SUNDRY NOTICES AND REPORTS ON WELLS
Do not use this form for proposals to drill or to re-enter an abandoned well. Use form 3160-3 (APD) for such proposals.

8. Well Name and No.
DIAMOND 31 FED COM 702H

EOG Resources requests an amendment to our approved APD for this well to reflect a change to a 4-string casing design as attached.

Revised Permit Information 5/24/18:

Lea County, New Mexico
Proposed Wellbore
Revised 5/24/18
API: 30-025-44758

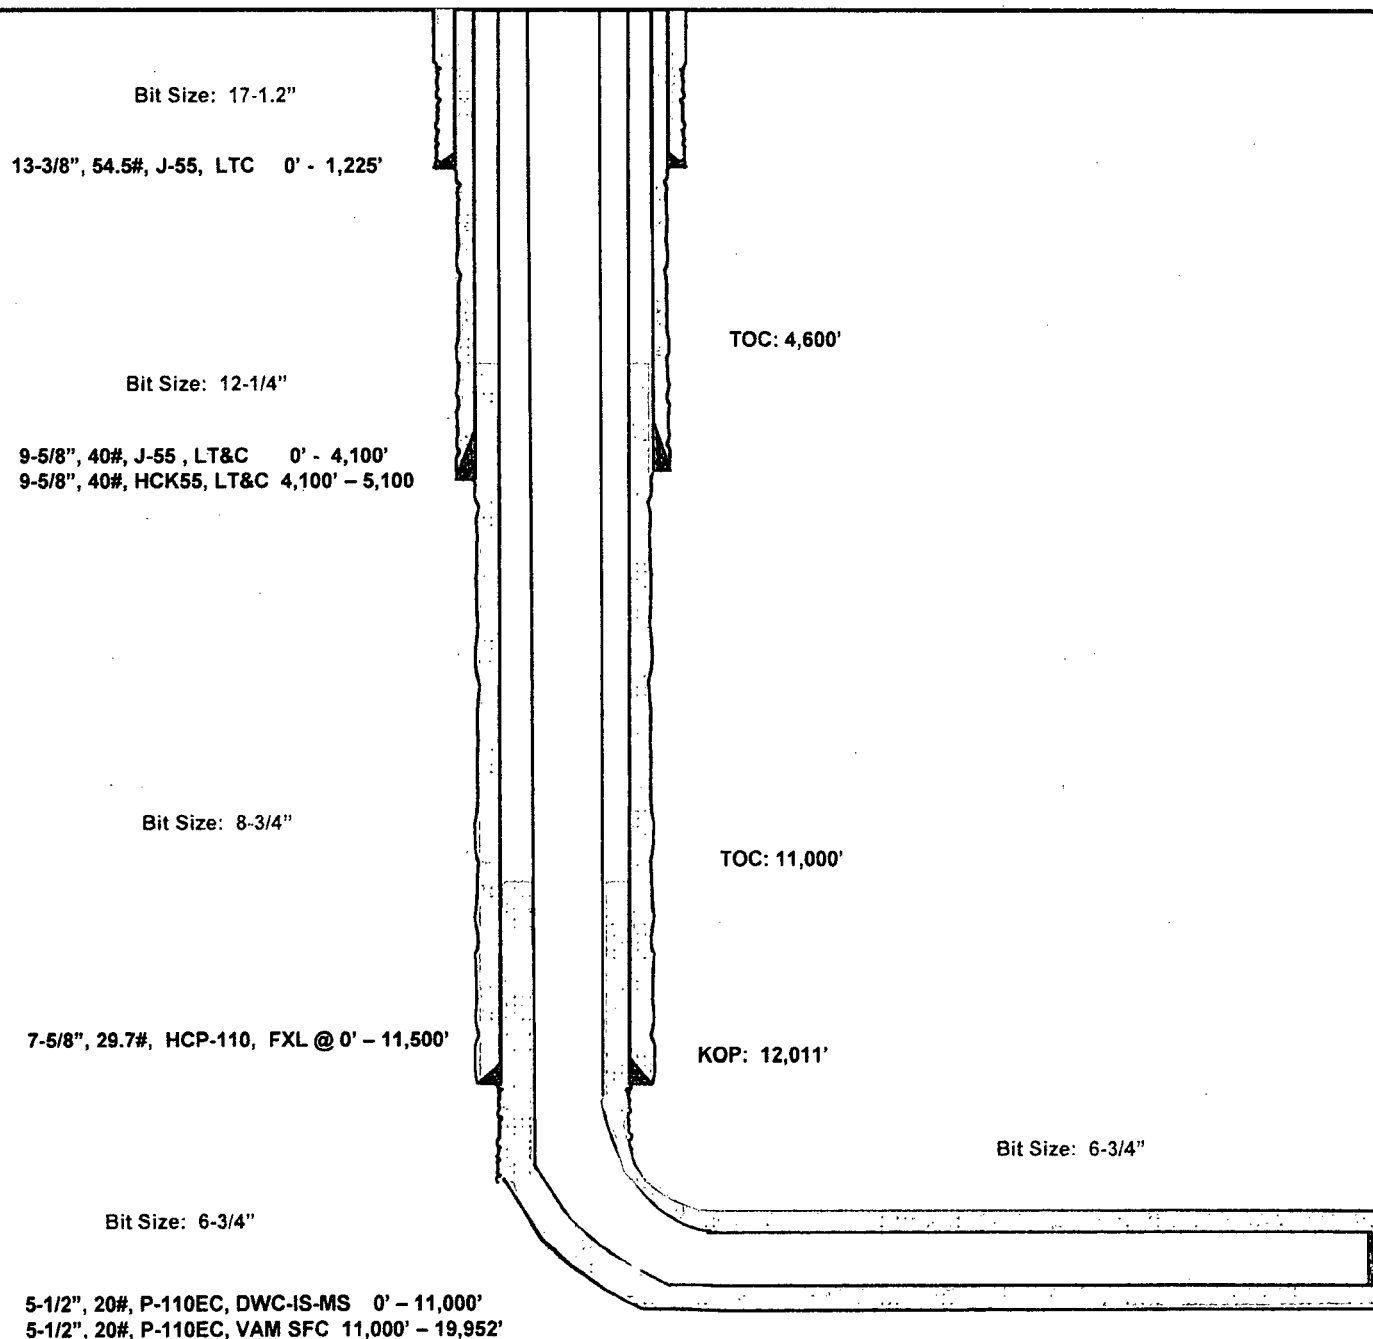
Variance is requested for annular clearance of the 5-1/2" x 7-5/8" to the top of cement.

Hole Size	Interval	Csg OD	Weight	Grade	Conn	DF _{min} Collapse	DF _{min} Burst	DF _{min} Tension
17.5"	0 – 1,225'	13.375"	54.5#	J55	STC	1.125	1.25	1.60
12.25"	0-4,100'	9.625"	40#	J55	LTC	1.125	1.25	1.60
12.25"	4,100' – 5,100'	9.625"	40#	HCK55	LTC	1.125	1.25	1.60
8.75"	0 – 11,500'	7.625"	29.7#	HCP110	FXL	1.125	1.25	1.60
6.75"	0 – 11,000'	5.5"	20#	P110EC	DWC CIS MS	1.125	1.25	1.60
6.75"	11,000' - 19,952'	5.5"	20#	P110EC	VAM SFC	1.125	1.25	1.60

Depth	No. Sacks	Wt. lb/gal	Yld Ft ³ /ft	Slurry Description
1,225'	697	13.5	1.74	Lead: Class 'C' + 4.00% Bentonite + 2.00% CaCl ₂ (TOC @ Surface)
	333	14.8	1.35	Tail: Class 'C' + 0.6% FL-62 + 0.25 lb/sk Cello-Flake + 0.2% Sodium Metasilicate + 2.0% KCl (1.06 lb/sk)
5,100'	692	12.7	2.22	Lead: Class C + 0.15% C-20 + 11.63 pps Salt + 0.1% C-51 + 0.75% C-41P (TOC @ Surface)
	303	14.8	1.32	Tail: Class C + 0.13% C-20
11,500'	375	10.8	3.67	Lead: Class C + 0.40% D013 + 0.20% D046 + 0.10% D065 + 0.20% D167 (TOC @ 4,600')
	400	14.8	2.38	Tail: Class H + 94.0 pps D909 + 0.25% D065 + 0.30% D167 + 0.02% D208 + 0.15% D800
19,952'	1000	14.8	1.31	Class H + 0.1% C-20 + 0.05% CSA-1000 + 0.20% C-49 + 0.40% C-17 (TOC @ 11,000')

Depth	Type	Weight (ppg)	Viscosity	Water Loss
0 – 1225'	Fresh - Gel	8.6-8.8	28-34	N/c
1225' – 5,100'	Brine	10.0-10.2	28-34	N/c
5,100' – 11,500'	Oil Base	8.7-9.4	58-68	N/c - 6
11,500' – 19,952' Lateral	Oil Base	10.0-11.5	58-68	3 - 6
